**TOWN OF MOUNTAIN VILLAGE  
REGULAR DESIGN REVIEW BOARD MEETING AGENDA  
THURSDAY FEBRUARY 1, 2024, 10:00 AM  
MOUNTAIN VILLAGE TOWN HALL  
455 MOUNTAIN VILLAGE BLVD, MOUNTAIN VILLAGE, COLORADO  
TO BE HELD HYBRID THROUGH ZOOM:  
<https://us06web.zoom.us/j/86027664518>  
Meeting ID: 860 2766 4518**

**TO:** Mountain Village Design Review Board  
**FROM:** Claire Perez, Planner II  
**FOR:** Design Review Board Public Hearing; February 1, 2023  
**DATE:** January 15, 2023  
**RE:** Staff Memo – Initial Architecture and Site Review (IASR) Lot 1 Unit 1, TBD Eagle Drive.

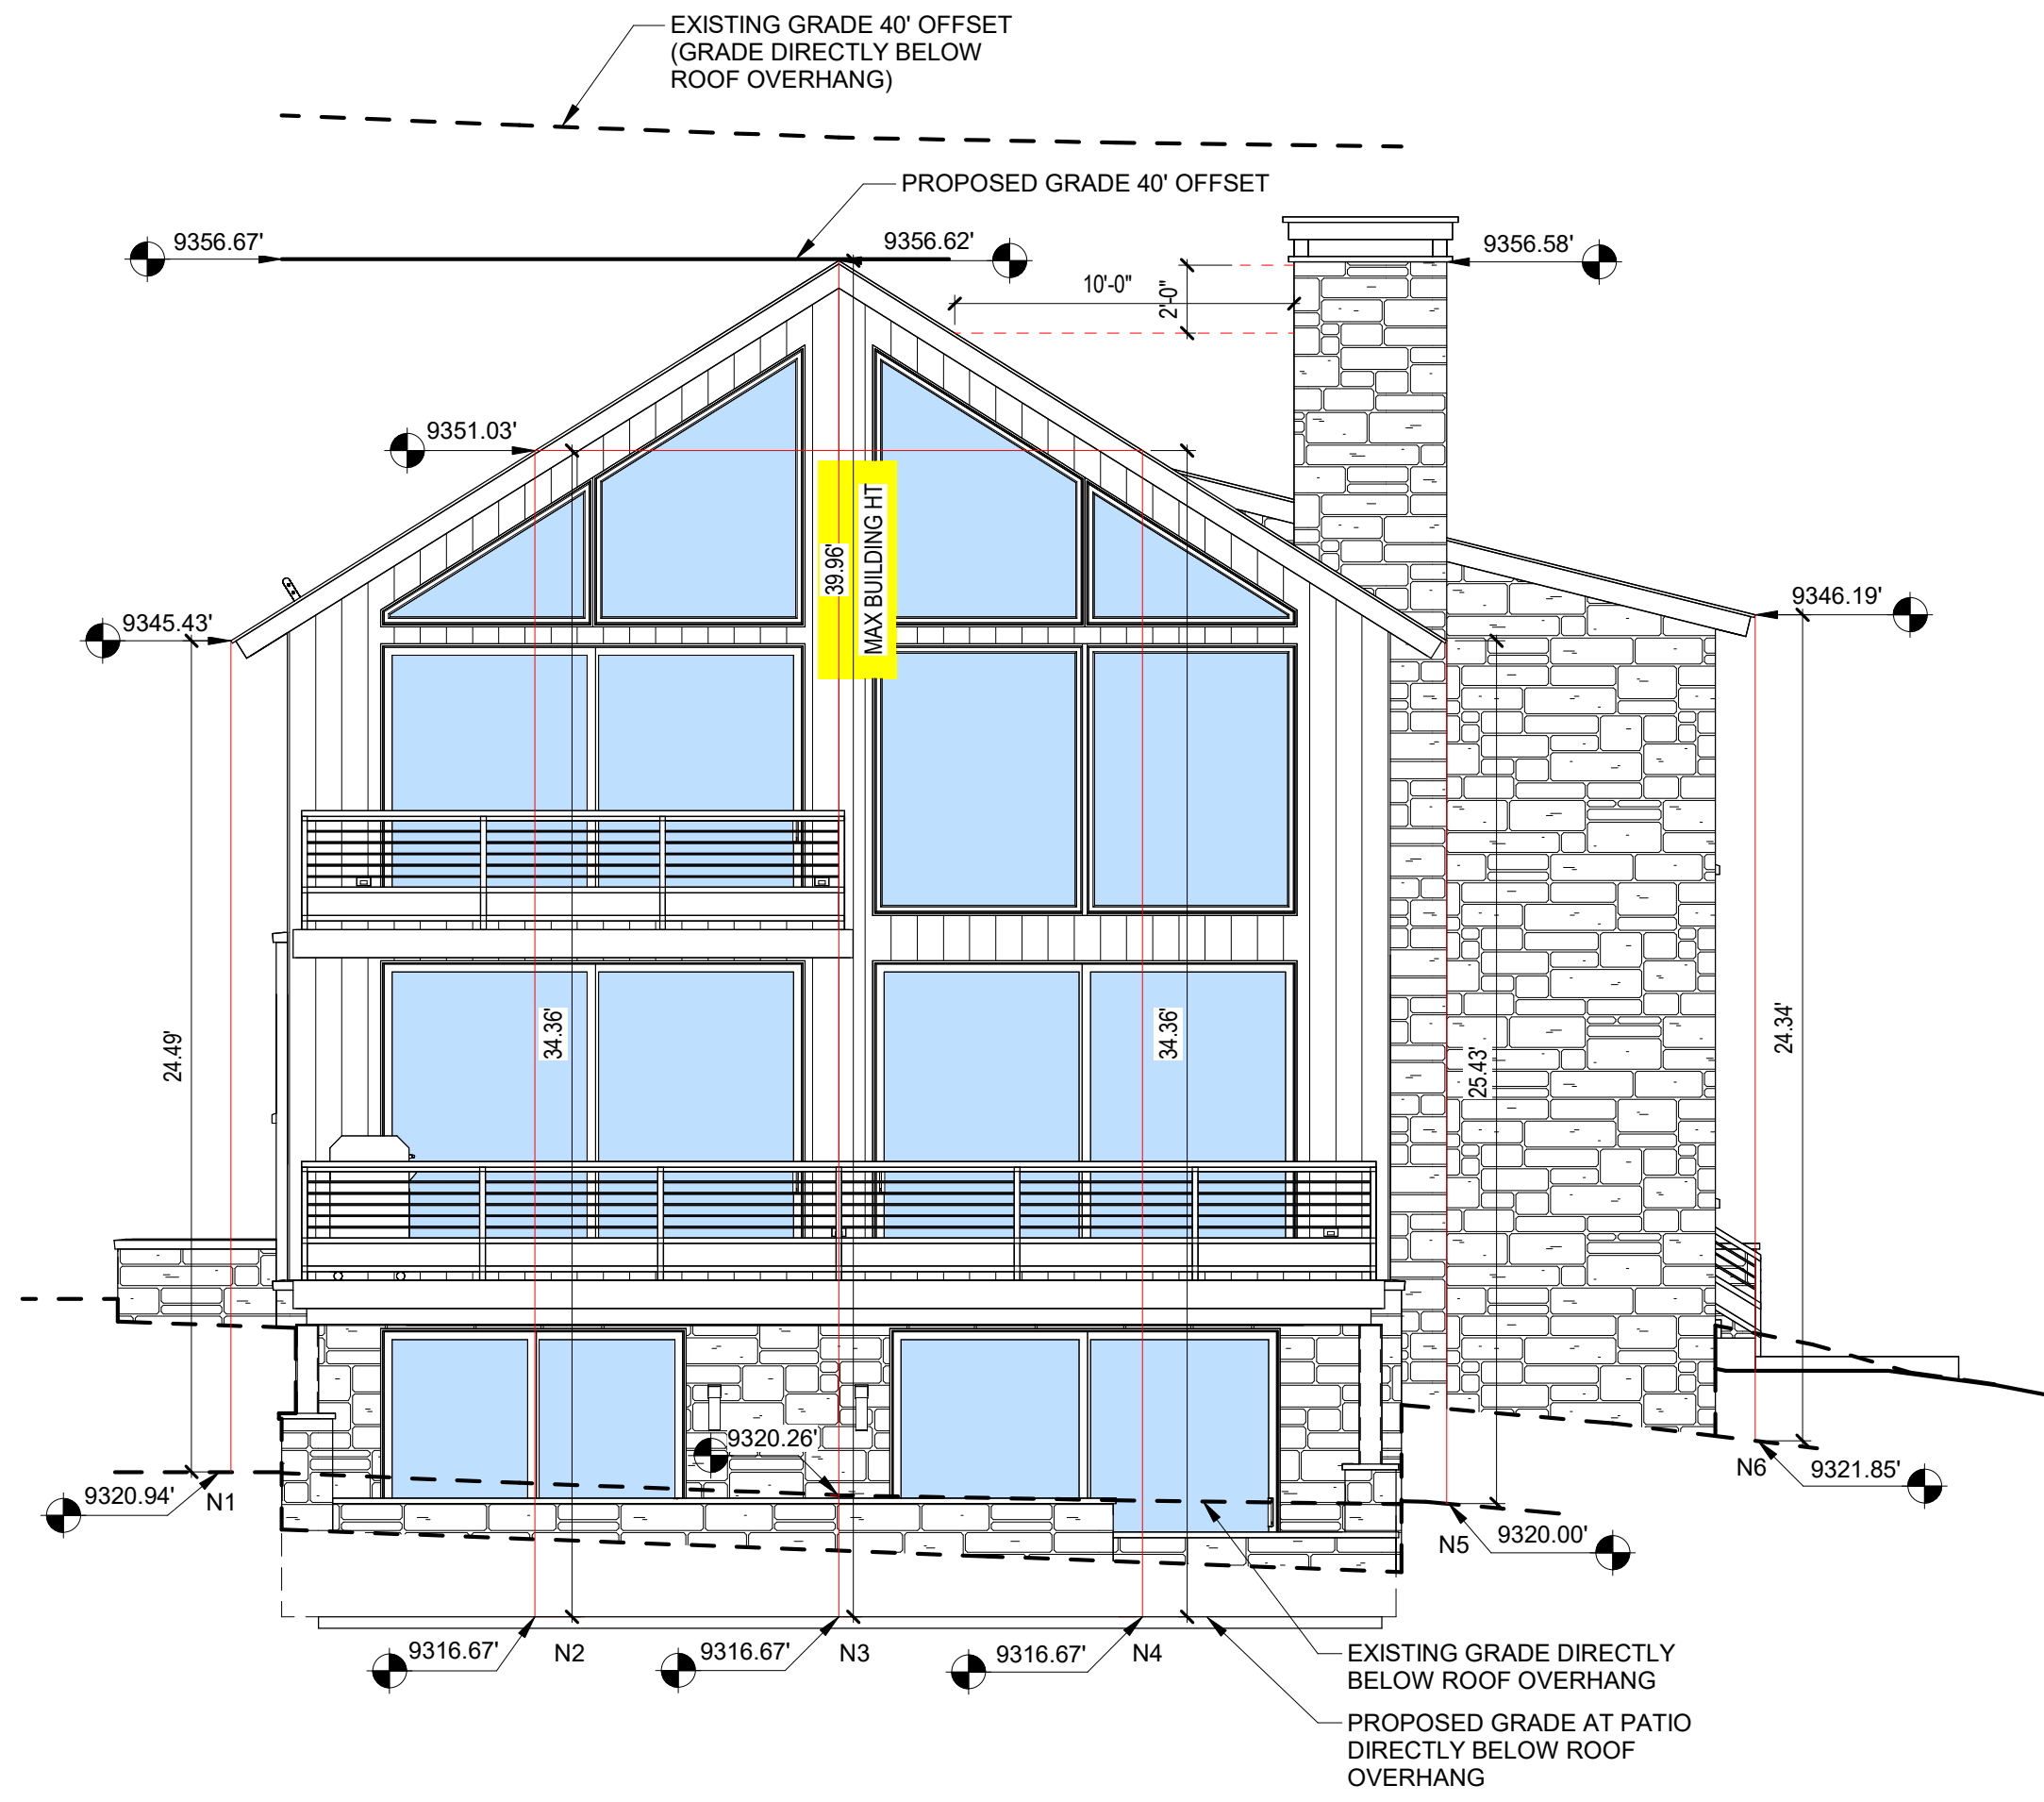
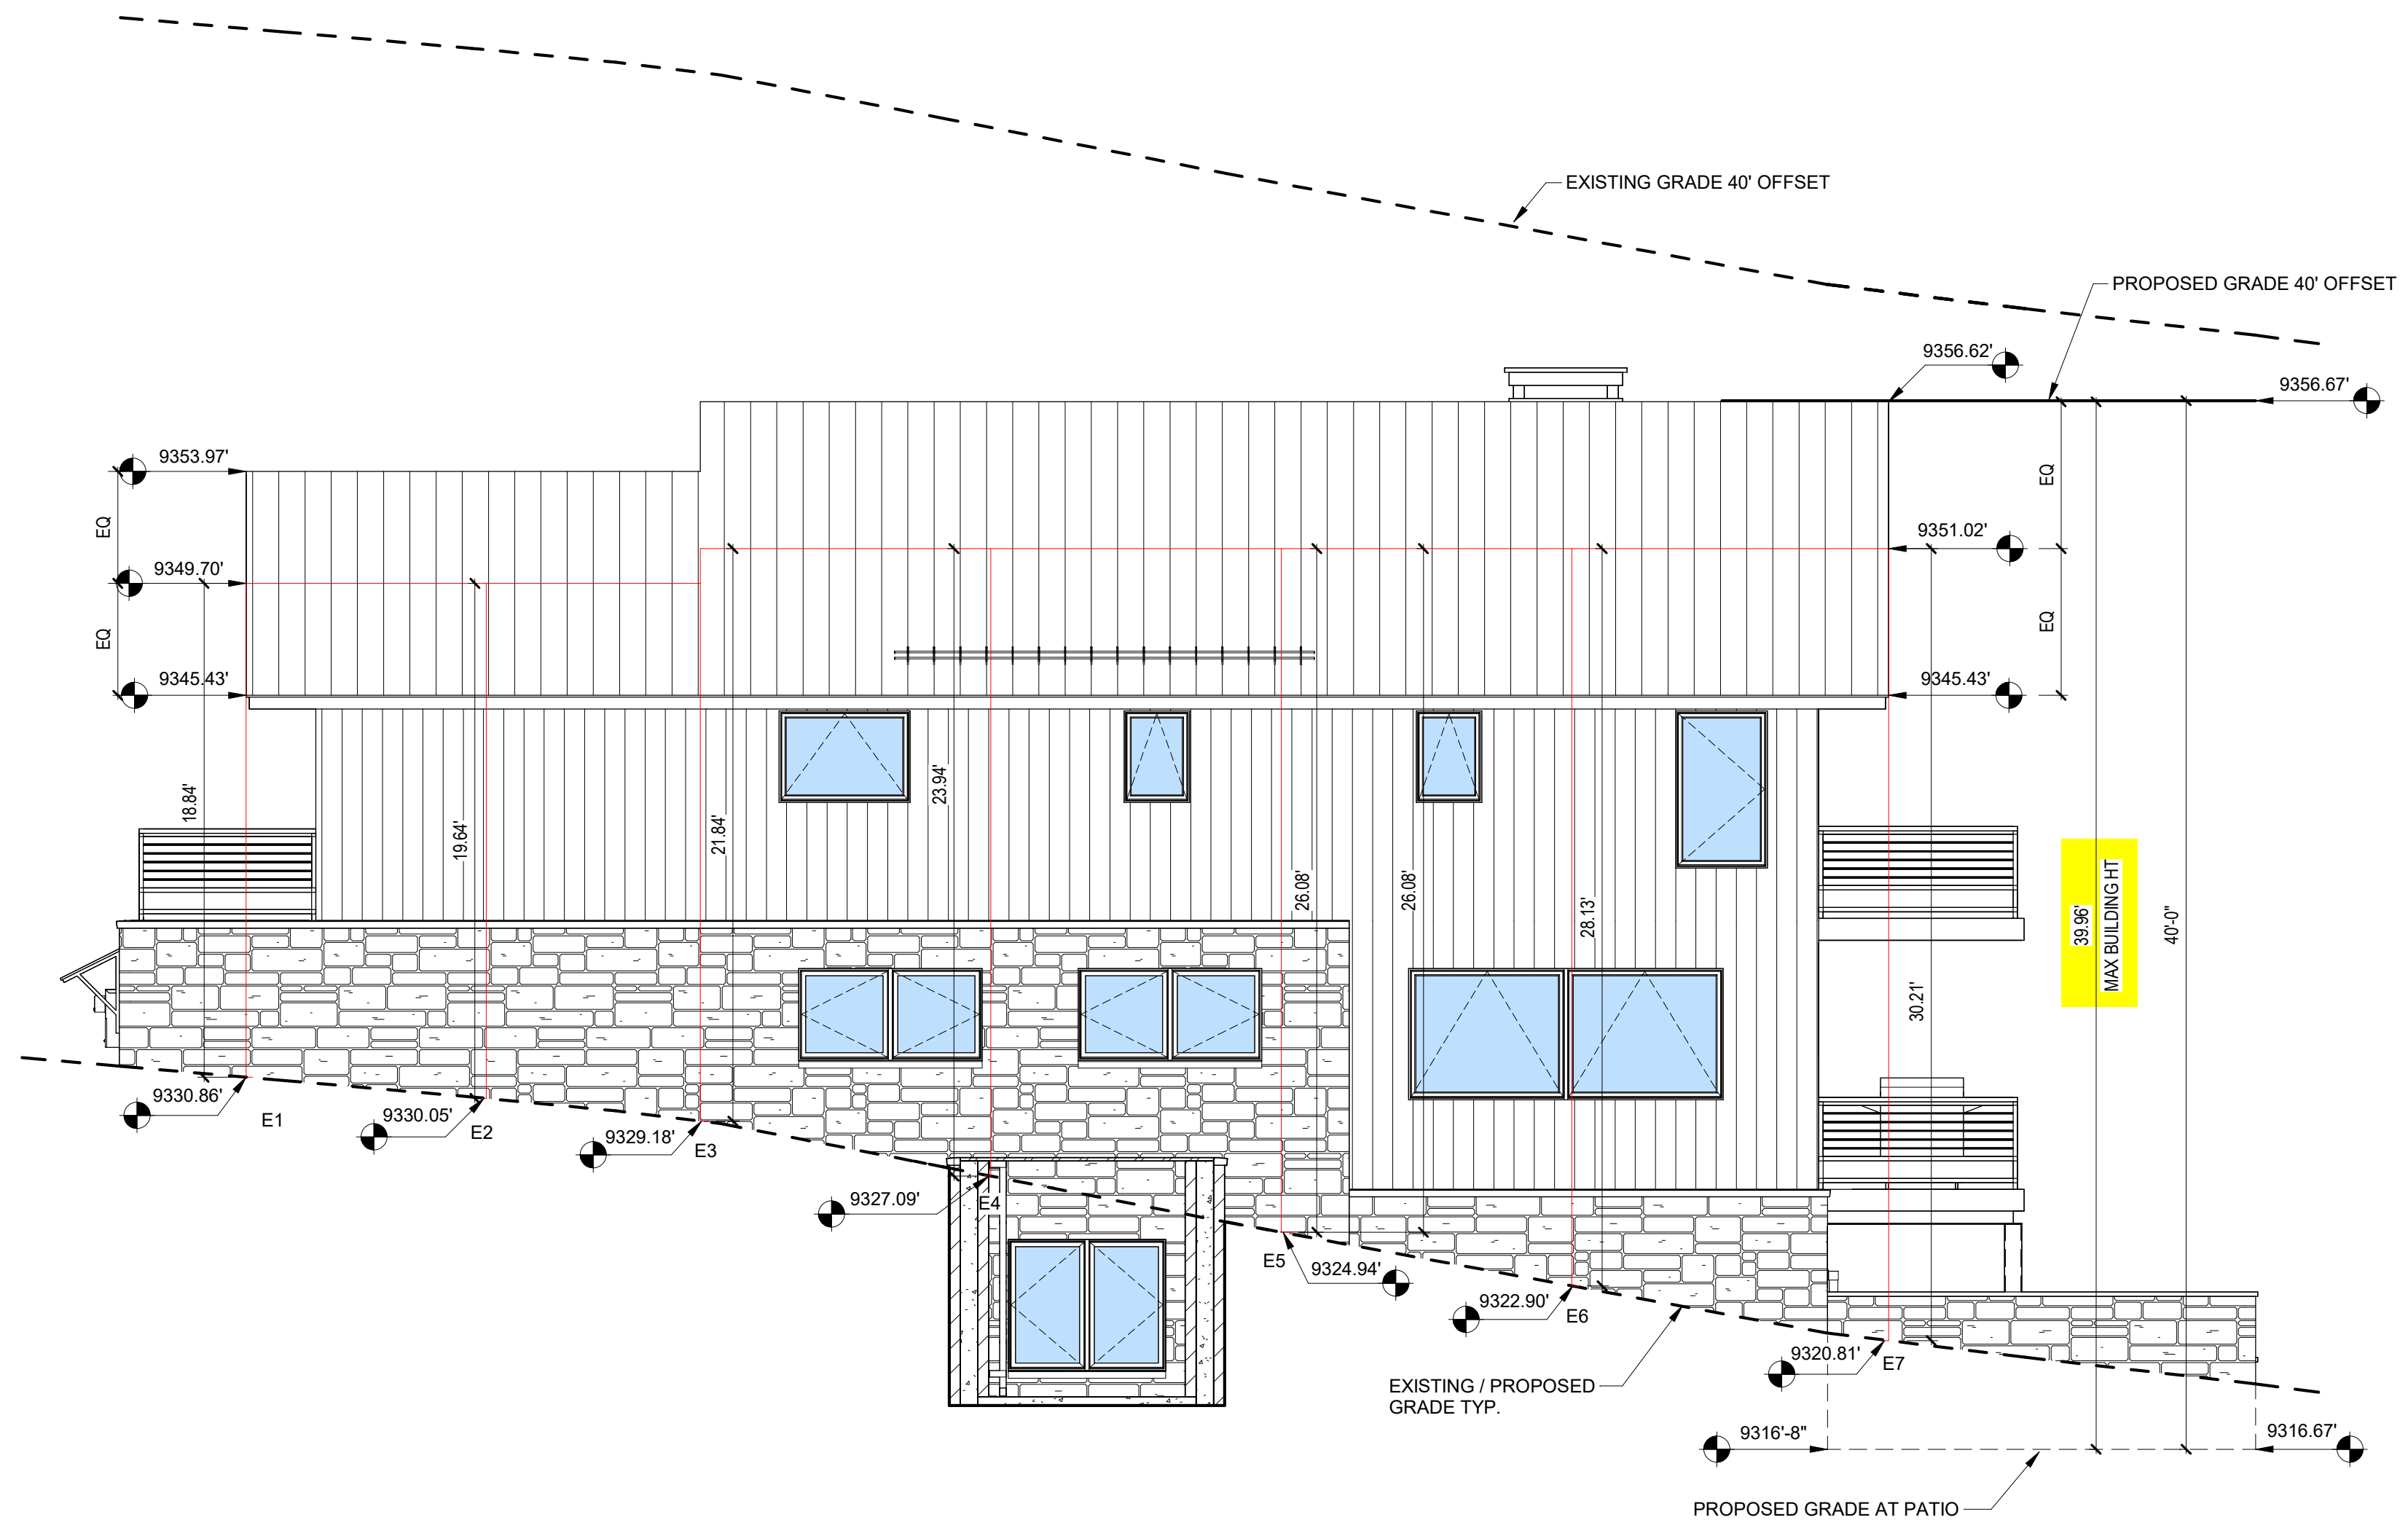
*Staff: Staff has determined that the primary roof form for the home is a gable roof and therefore is granted a maximum height of 40' and an average height of 35'. The applicant has calculated a maximum height of 39.96' and an average height of 25.31'. The CDC allows chimneys and similar structures to extend 5' past the maximum building height. The chimney cap height is shown as 2'-10" on sheet A4.2 Staff finds this criteria met.*
